UNITED STATES PATENT AND TRADEMARK OFFICE

10/578,869

Office Action Summary	Application No. 10/578,869	Applicant(s) SHOJI, HONDA	
	Examiner JOSHUA KING	Art Unit 2828

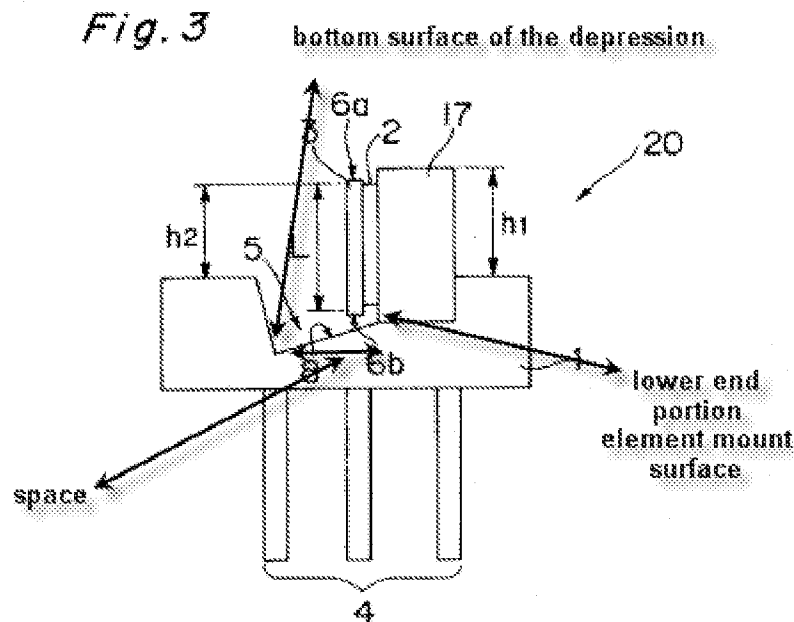
2. Applicant's arguments filed 02/01/2008 have been fully considered but they are not persuasive. In short, the applicant's amendment has not overcome the previous rejection because Hosokawa et al. (U.S. Pre-Grant Publication 2004/0105472) still shows "a lower end portion of the element mount surface and a bottom surface of the depression face each other with a space left there between". The examiner has provided a mark-up of Fig. 3 which shows how this limitation is met by the figure below.

8. Claims 1-7 are rejected under 35 U.S.C. 102(e) as being anticipated by Hosokawa et al. (U.S. Pre-Grant Publication 2004/0105472).
9. **With respect to claim 1**, Hosokawa et al. discloses a base portion having a horizontal top surface (Fig. 3 element 1); a heat sink portion that has a vertical element mount surface and is located above the top surface of the base portion (Fig. 3 element 17); a semiconductor laser element that is fixed to the element mount surface (Fig. 3 element 3); and a depression that is formed in the top surface of the base portion located immediately below the semiconductor laser element so as to receive part of the semiconductor laser element disposed therein (Fig. 3 element 5), wherein the heat sink portion is fixed to the base portion in such a way that the element mount surface is located inward of an inner side surface of the depression (Fig. 3 elements 5 and 17), and that a lower end portion of the element mount surface (Fig. 3 element 17) and a

bottom surface of the depression face each other with a space left there between (Fig. 3 element 5).

3. The examiner recommends applicant considers amending claim 1, to further include a recitation defining how the bottom surface of the heat sink contacts the base portion. As shown in Figs. 3 and 4 of Hosokawa et al., the base portion and heat sink are in full contact over the entire width of the heat sink element. However, as disclosed in Figures 1, 3, and 4 of the instant application the bottom width of the heat sink is shown to overlap the depression. Such a recitation might read as "the heat sink portion is positioned such that the bottom surface of the heat sink portion is not completely

contacted by the base portion, such that the bottom of the element mount surface does not contact the base portion". The examiner believes that such a recitation would overcome the rejection cited in this office action. Please note, that the examiner **IS NOT** indicating any material as allowable, only that such a recitation would overcome the current rejection.
